In Reply Refer To:  
Docket: STN 50-482/90-08

Subject: Docket No. 50-482: Response to Inspection Report 90-08

**Response to Inspection Report 90-08**

Figure 1

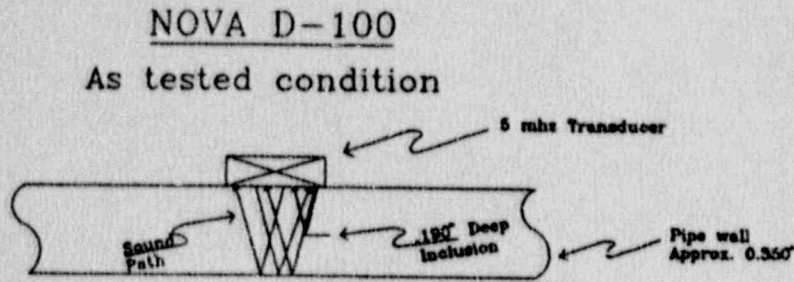
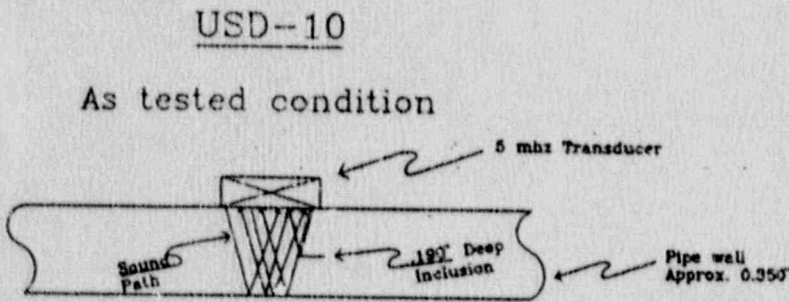
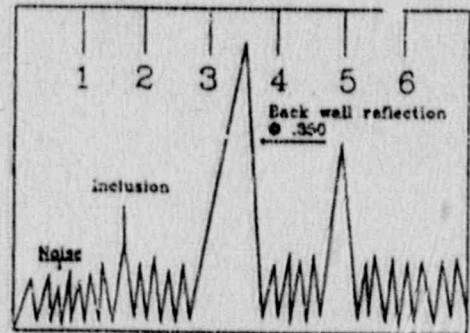
The results of the examination for erosion/corrosion of selected components from the Essential Service Water System revealed isolated areas that appeared to have pits or material anomalies. Thickness measurements taken by the NRC inspectors were compared to those taken by the licensee to verify areas which may be below minimum wall thickness. Because of the two different instruments used in taking measurements (NRC used a Nova D100 digital gage the licensee used a Krautkramer USD-10 Ultrasonic Flaw Detector) there were areas that required further investigation, this was accomplished by having the NRC inspector and the licensee's inspector take the two instruments and compare the individual thickness readings. Using the digital thickness gage the indications were easily found and duplicated, however, the Ultrasonic Flaw detector could not find the same indications. The indications identified did not appear to be significant enough to threaten the integrity of the components. However, the issue was identified to licensee management so that they can review the effectiveness of the techniques being used in the erosion-corrosion program and take any appropriate corrective actions.

The USD-10 is a state-of-the-art, versatile flaw detection instrument utilized to evaluate and size small anomalies found during erosion-corrosion and Inservice inspection examinations. The signal from the I.D. surface as well as volumetric anomalies will be detected and displayed on the screen which allows evaluation of the signal. Figure 1 illustrates the D100 and the USD-10 displays.

WCNOG performed an examination of the isolated areas that appeared to have anomalies with the DMX-1 instrument and identified the same anomalies as the NRC had identified. A follow-up examination using the USD-10 was performed. The areas were examined and no relevant I.D. flaws or significant volumetric flaws were identified. This is based on an evaluation of the USD-10 signal that displayed a back wall reflection at the nominal wall value (0.350"). The signal from the anomaly was the same amplitude as that contained in the noise level of the scope indicating that the signal recorded by the Nova D100 was the result of a small material anomaly (such as an inclusion).
